Tres Suenos Unit Sixteen

City of El Paso — City Plan Commission — 9/20/2018

SUSU18-00072 — Major Preliminary (REVISED)

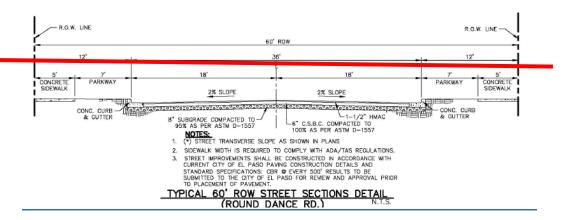
• To allow a 60' ROW with 36' of pavement, 7' landscape and 5' sidewalk.

TYPICAL 52' ROW STREET SECTIONS DETAIL
(RESIDENTIAL SUB COLLECTOR) SCALE: N.T.S.

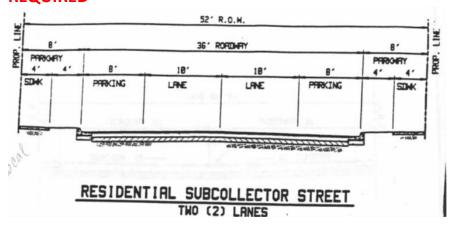
• To allow a 52' ROW with 32' of pavement, 5' landscape and 5' sidewalk.

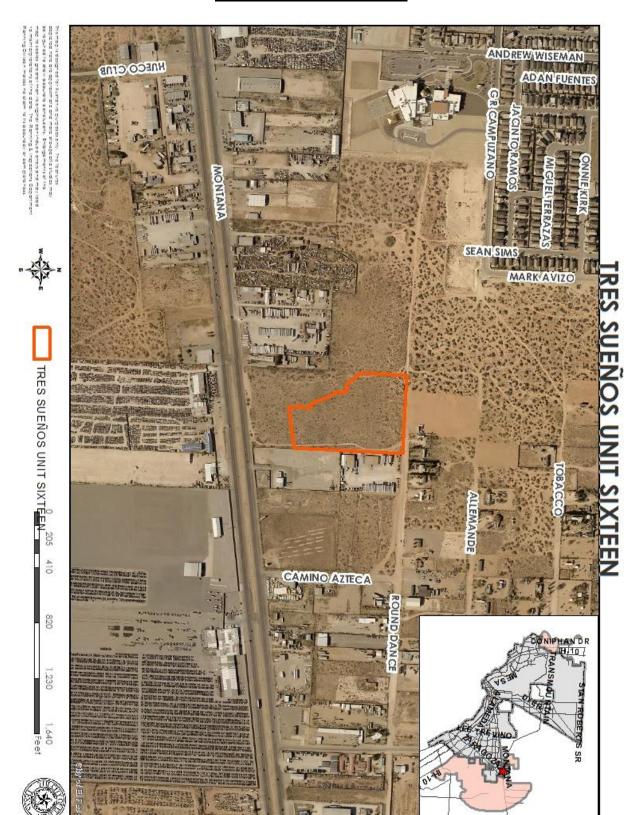
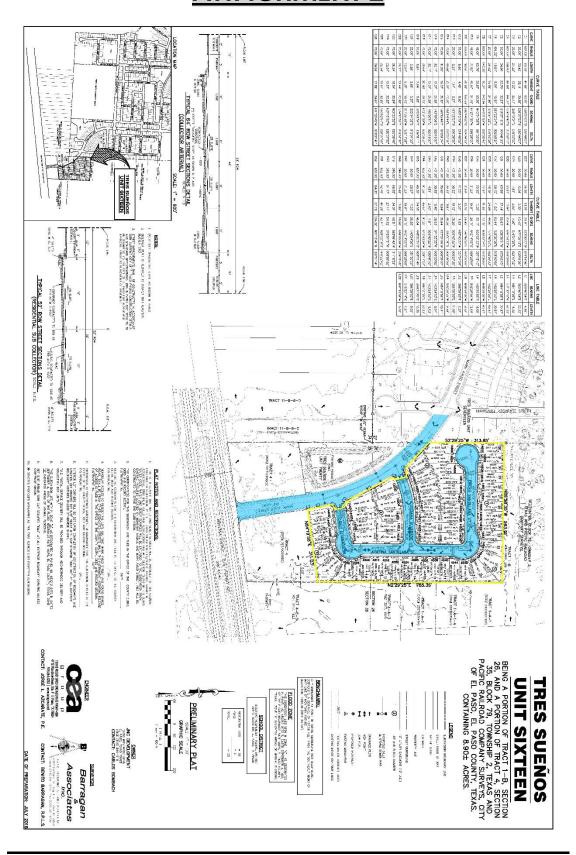
- All downstream storm water management facilities should be in place prior to development of the subject subdivision.
- Confirm that existing downstream conveyance structures have sufficient capacity to handle the developed runoff from the proposed subdivision.

A 16-inch diameter water main is required to be extended along Mark Aviso St., and water mains will be required to extend along Carlo Alvaro Dr., Luciana Alvaro Dr., Maria Josefina Santillana St. and Ericka Santillana Ct.

Change Block 1 to 70 Change Block 2 to 71 Change Block 3 to 72
